#### BID BULLETIN No.1

20 October 2023 (Friday)

BIDDING NO.:	Title/Description:
IB23-408235-04	
Approved Budget Ceiling (ABC):	INSTALLATION, CONFIGURATION, TESTING
3,500,000. <u>°°</u>	& COMMISSIONING, AND UPGRADING OF
Date of Pre Bid Conference	THE CLOSED-CIRCUIT TELEVISION
10 October 2023 (Tuesday); 10:00 AM	SURVEILLANCE SYSTEM AT DAP
Via Google Meet Platform	SURVEILLANCE STSTEM AT DAP
meet.google.com/uun-xyfm-ssr

Relative to the conducted Pre-Bid Conference via Google Meet for the above-stated Project last October 10, 2023 (Tuesday) and the conducted site visit last October 12-13, 2023, the following clarifications from prospective bidders are being posted for the information of all concerned, as approved by the BAC & TWG:

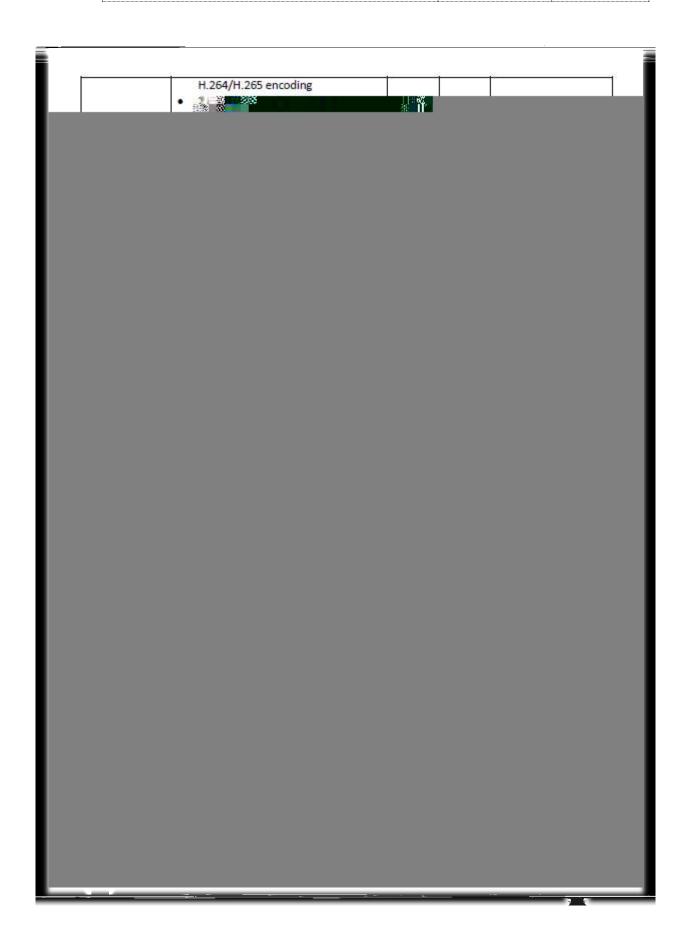
-with plotting of cable tray or desired location on where the cable tray to be layout in your premises

-with detailed dimension and exact location of existing camera with label or numbering that to be upgraded and additional IP Camera

-Revised Form 2: Price Schedule for the requested floor plans, CCTV locations, view,
